To: T10 Technical Committee
From: Rob Elliott, HP (elliott@hp.com)
Date: 14 January 2008
Subject: 08-009r1 SAS-2 Elasticity buffer clarifications

Overview

This proposal clarifies issues regarding deletable primitives and the elasticity buffer.

Figure 36 — Receive data path in a SAS phy

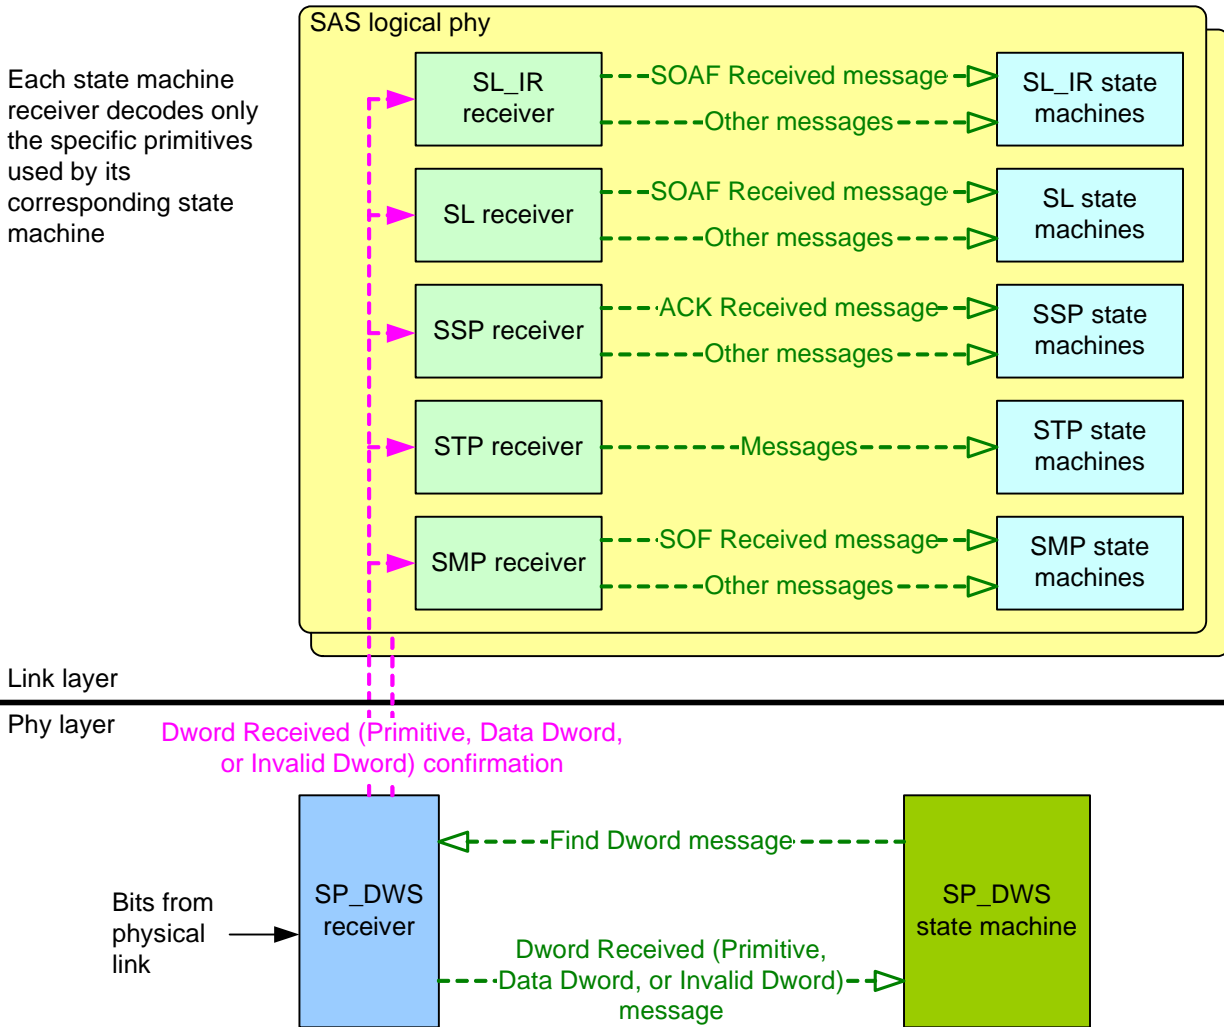
See figure 156 in 7.3.1 for more information about the elasticity buffer, which is not shown in figure 36.

Figure 37 — Receive data path in an expander phy

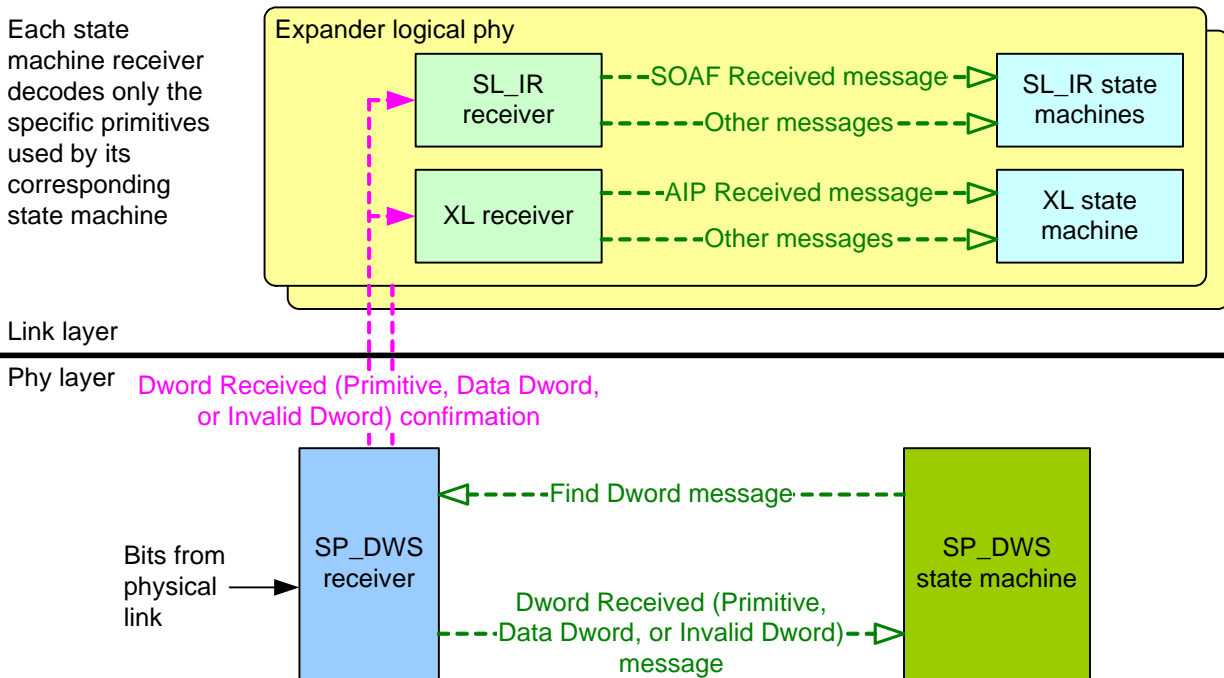
See figure 156 in 7.3.1 for more information about the elasticity buffer, which is not shown in figure 37.

Figure 156 — Elasticity buffers

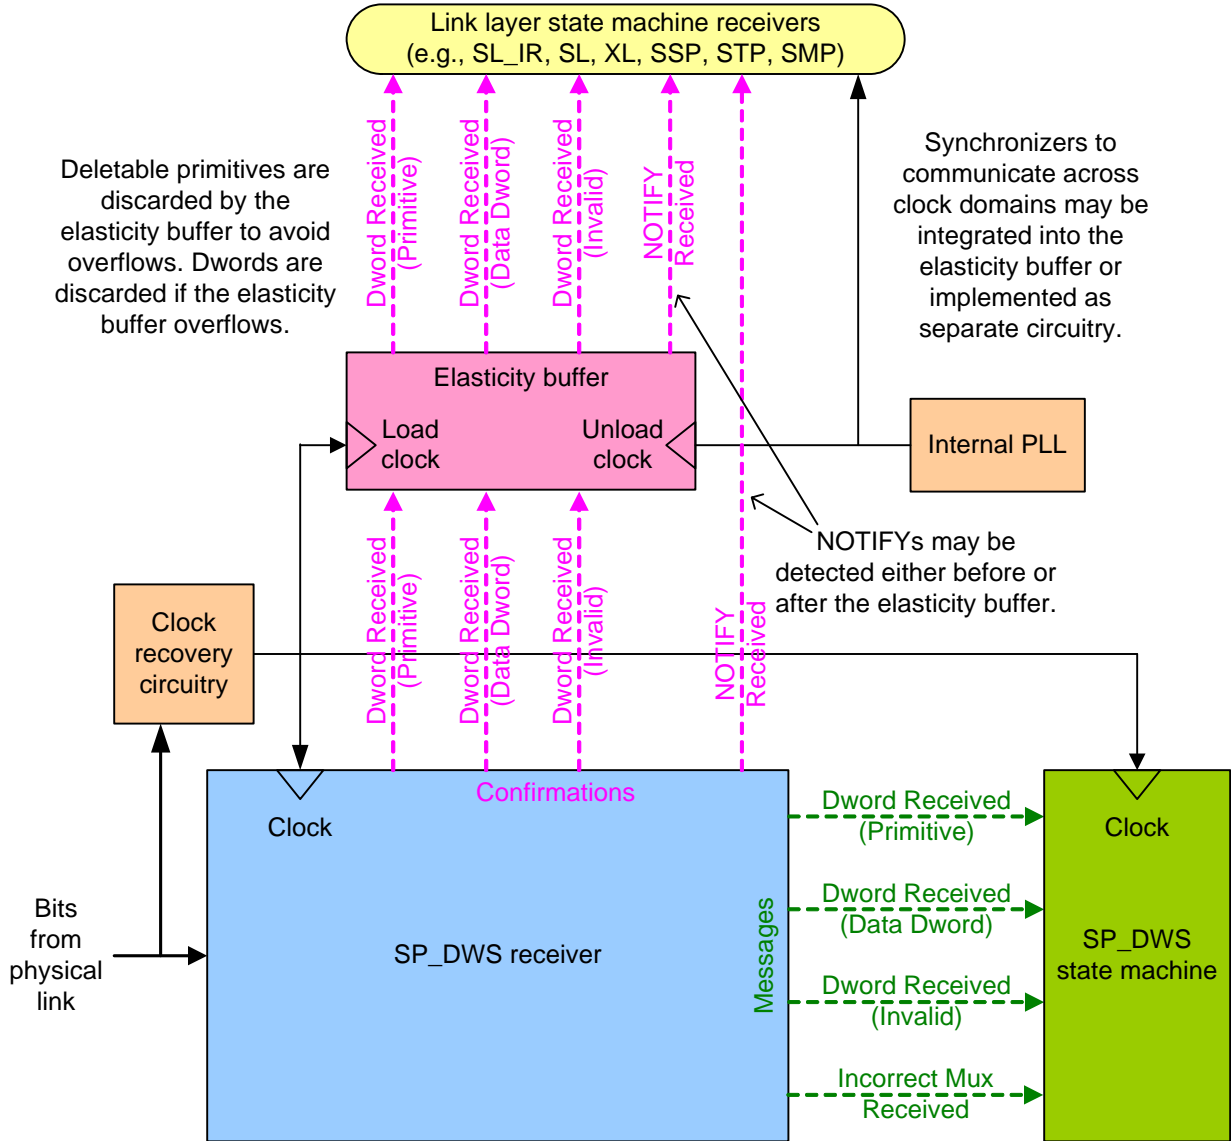
1. Based on feedback from a SAS-2 editing session, the elasticity buffer figure is redrawn to show more detail about how the elasticity buffer interacts of the state machines.

Elasticity buffer circuitry, as shown in figure 156, Circuitry (e.g., an elasticity buffer) is required to absorb the slight differences in frequencies between the phys. Figure 156 shows an example of an elasticity buffer. The frequency tolerance for a phy is specified in 5.3.3. The depth of the elasticity buffer is vendor-specific but shall accommodate the physical link rate tolerance management deletable primitive insertion requirements in table 119 (see 7.3.2).
